## MEMORANDUM

**Subject:** **Errata for the Star Express Car Wash Project Public Review Draft Initial Study/Mitigated Negative Declaration**

Exhibit 2-3

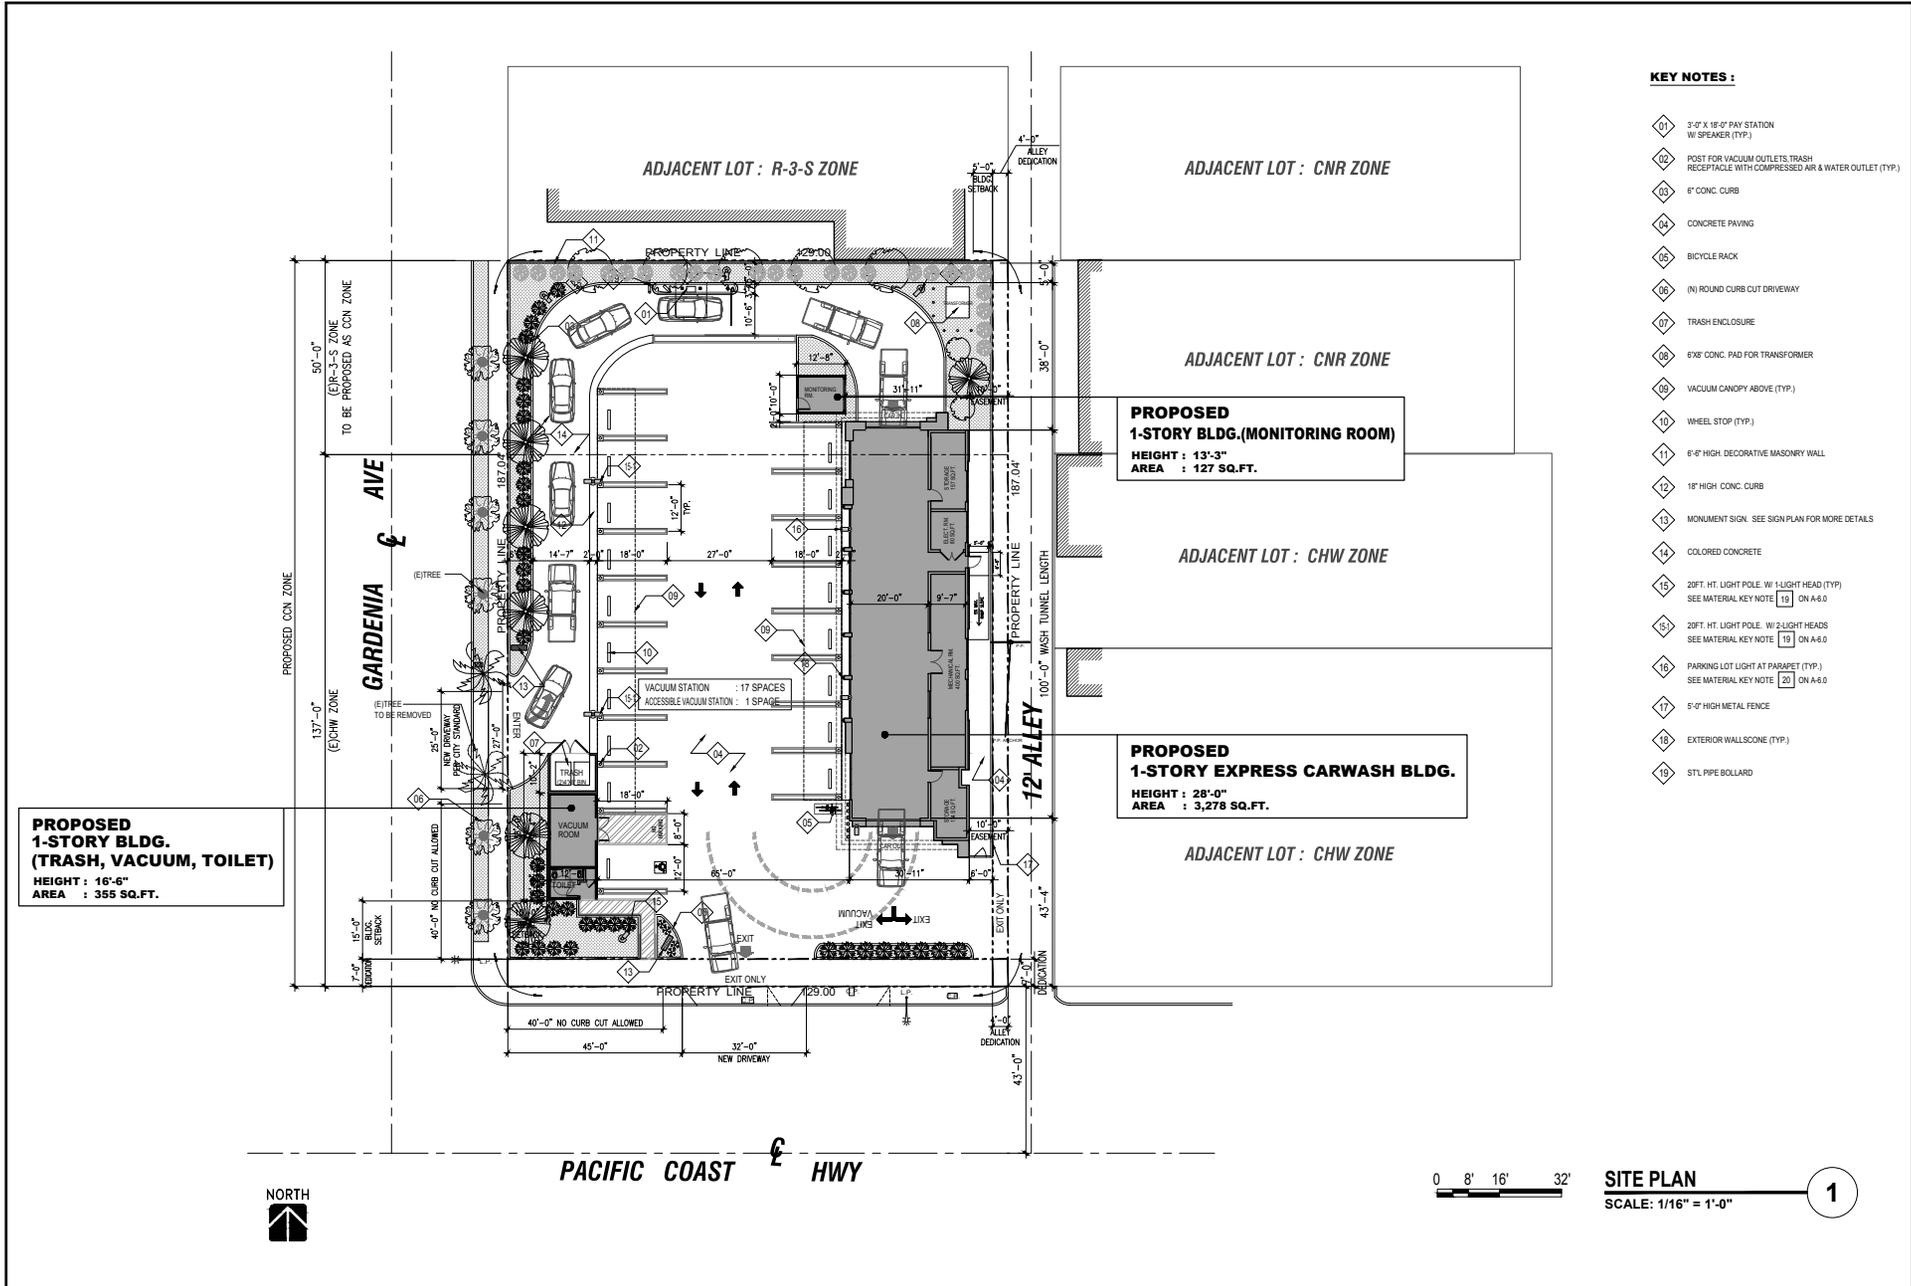
The City has identified an administrative update to the requested zone change. Rather than rezoning the entire project site to CHW, the proposed modification would rezone the merged lot to Community R-4-N Commercial (CCN). Based on *Long Beach Municipal Code* (LBMC) Section 21.32.020(C), the Community Commercial zoning districts provide medium scale uses that serve an entire community, including those who arrive by automobile, and which may require buffering to ensure compatibility with adjacent residential neighborhoods. These districts are located on major or minor arterials, located on larger lot sizes and adjoining larger scale residential neighborhood uses, or are buffered from smaller scale residential neighborhoods. There are four types of Community Commercial zoning districts including the CCN zoning district. The CCN district permits retail and service uses for an entire community, including convenience and

comparison shopping for goods and associated services and also permits medium density residential development at Medium-Density Multiple Residential (R-4-N) densities. Refer to Attachment A for an updated Exhibit 2-3, *Proposed Site Plan*, that reflects the modified zone change.
